Access Compliance Report

Public Rights-of-Way

(Pedestrian Signals)

Intersection ID: N/A	Main Street:	Cross Street: N/A	Location: N/A
ADA ID: 6B23965E7D91	Signal Type: Two Push Buttons-Non APS	Overall Compliance: No	Severity Score: BTN 1:N/A BTN 2: N/A No BTN: N/A
Codes/Mitigation Info/Possible Solution		Field Measurements/Component Compliance

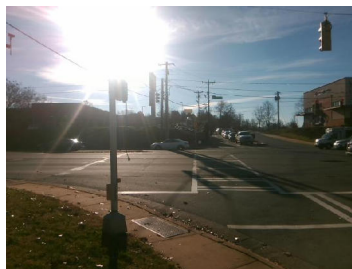
PROW/ADA: R404.3, R404.2, R406.2, TMUTCD 4e.08

Possible Solutions: Provide PAR As Indicated. Provide Push Button Extension. Remove and Replace Clear Space. Replace Signal Push Button With APS Button on New Post. Remove & Relocate Sign.
